**CALCULATION PLAN**

$\Delta$			
$\Delta$			
$\Delta$	INCREASE LENGTHS TO SATISFY REQUIREMENTS FOR LENGTH @ MEAN TEMPERATURE OF 45°F.	JSA	9/17/04
NO.	REVISION	BY	DATE
<b>HIGH STEEL STRUCTURES, INC.</b>  1770 Hempstead Road Lancaster, PA 17605-0008 Phone 717/299-5211 A Division of High Industries, Inc.			
WORKSHEET ~ CALCULATION PLAN			
VT 78 OVER MISSISQUOI BAY, BRIDGE NO. 2			
VT 78 STA. 10+970.425 TO STA. 12+059.775			
TOWNS OF ALBURG AND SWANTON			
COUNTIES OF GRAND ISLE AND FRANKLIN			
STATE OF VERMONT, AGENCY OF TRANSPORTATION			
STATE CONTRACT OR REF. NO. BRF-036-1(1)			
CONTRACTOR <b>CANBRO CORPORATION</b>			
IN CHARGE: <u>GLIDDEN (IH)</u>	MADE BY: <u>JSA</u>	CHK'D. BY: <u>CS</u>	DATE: <u>8-9-04</u>
CONTRACT NUMBER: <u>VT-04057-1,2&amp;3</u>		DRAWING NUMBER: <u>WS1 OF WS12</u>

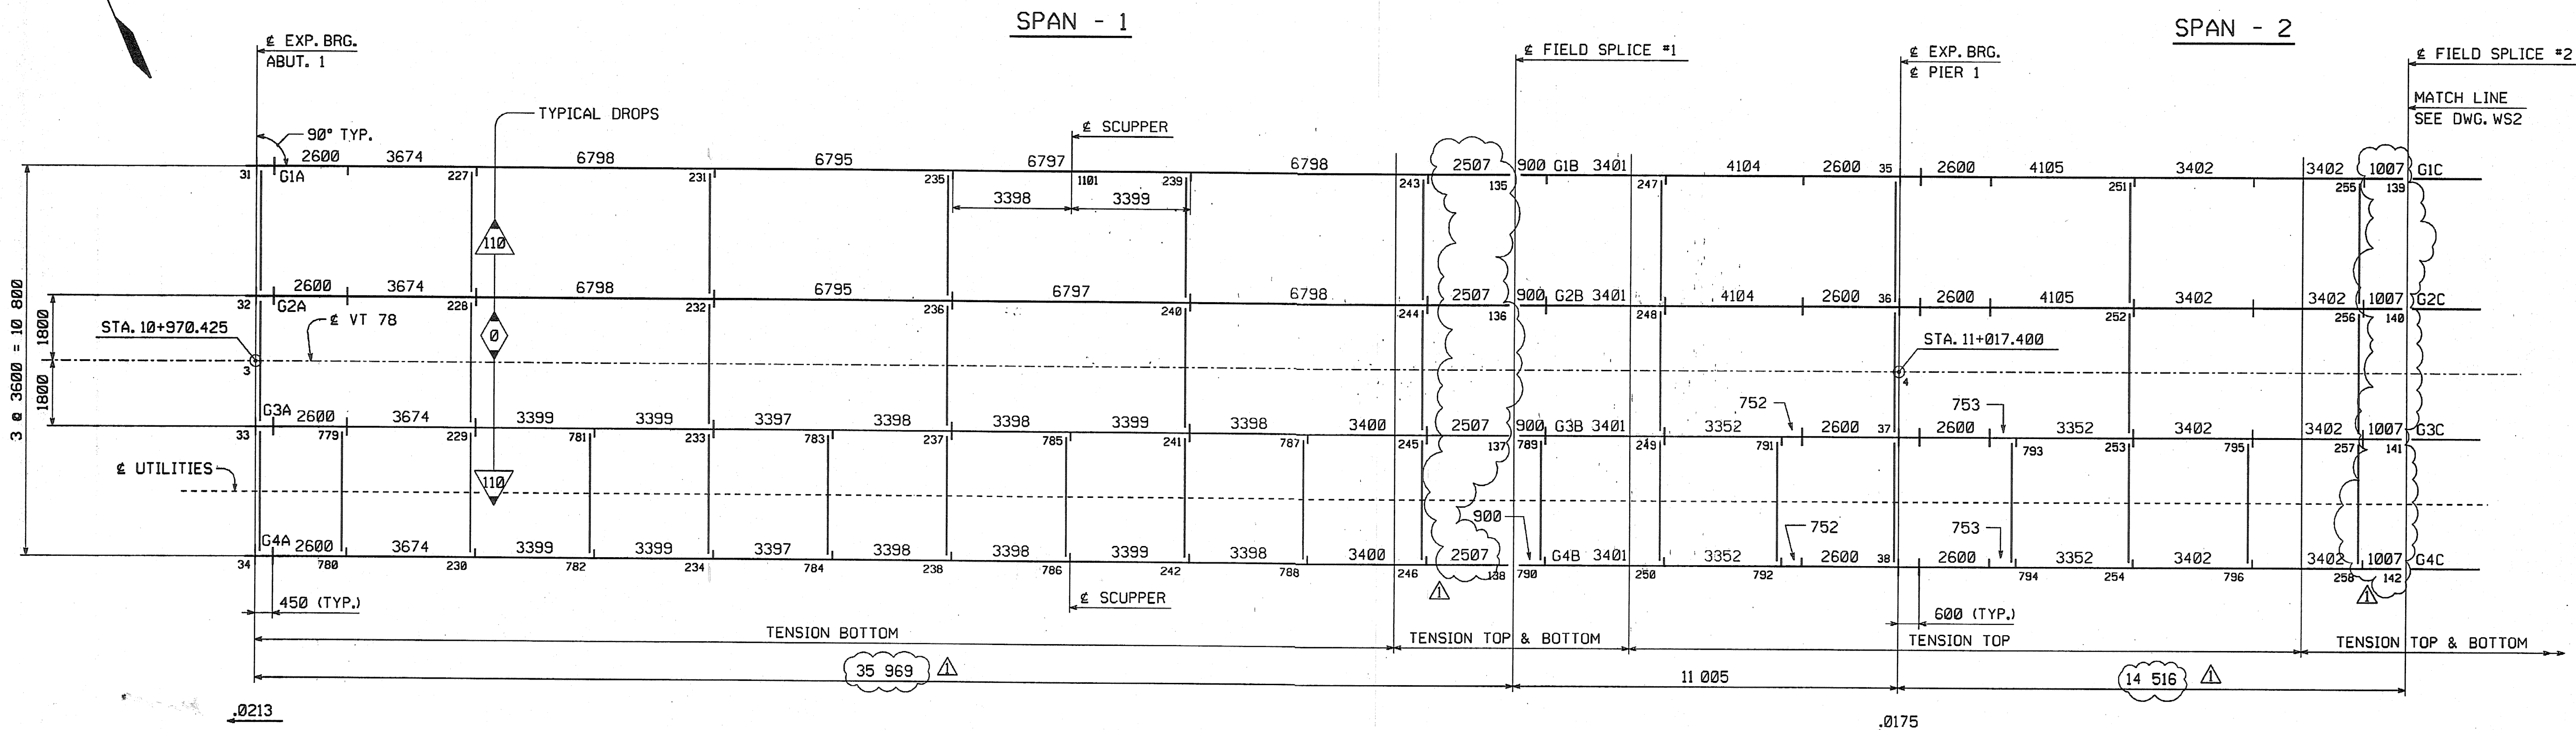
CONTRACT PLAN LENGTHS HAVE BEEN INCREASED AS REQUIRED TO SATISFY MEAN TEMPERATURE LENGTH AT FORTY-FIVE DEGREES WITH FABRICATION AT SIXTY-EIGHT DEGREES MEAN TEMPERATURE

SHOP DRAWING REVIEW	
<input checked="" type="checkbox"/> REVIEWED AS REQUIRED BY THE CONSTRUCTION CONTRACT DOCUMENTS AND APPROVED, BUT ONLY FOR COMPLIANCE TO THE DESIGN CONCEPT OF THE WORK, AND SUBJECT TO FURTHER LIMITATIONS AND REQUIREMENTS CONTAINED IN THE CONSTRUCTION CONTRACT DOCUMENTS.	
<input type="checkbox"/> REJECTED	<input type="checkbox"/> REVISE AND RESUBMIT
CORRECTIONS OR COMMENTS MADE ON THE SHOP DRAWINGS DURING THIS REVIEW DO NOT RELIEVE CONTRACTOR FROM COMPLIANCE WITH REQUIREMENTS OF THE DRAWINGS AND SPECIFICATIONS. THIS CHECK IS ONLY FOR REVIEW OF GENERAL COMPLIANCE WITH THE DESIGN CONCEPT OF THE PROJECT AND GENERAL COMPLIANCE WITH THE INFORMATION GIVEN IN THE CONTRACT DOCUMENTS. THE CONTRACTOR IS RESPONSIBLE FOR CORRECTING AND CORRELATING ALL QUANTITIES AND DIMENSIONS; SELECTING FABRICATION PROCESSES AND TECHNIQUES OF CONSTRUCTION; COORDINATING HIS WORK WITH THAT OF ALL OTHER TRADES; AND PERFORMING HIS WORK IN A SAFE AND SATISFACTORY MANNER.
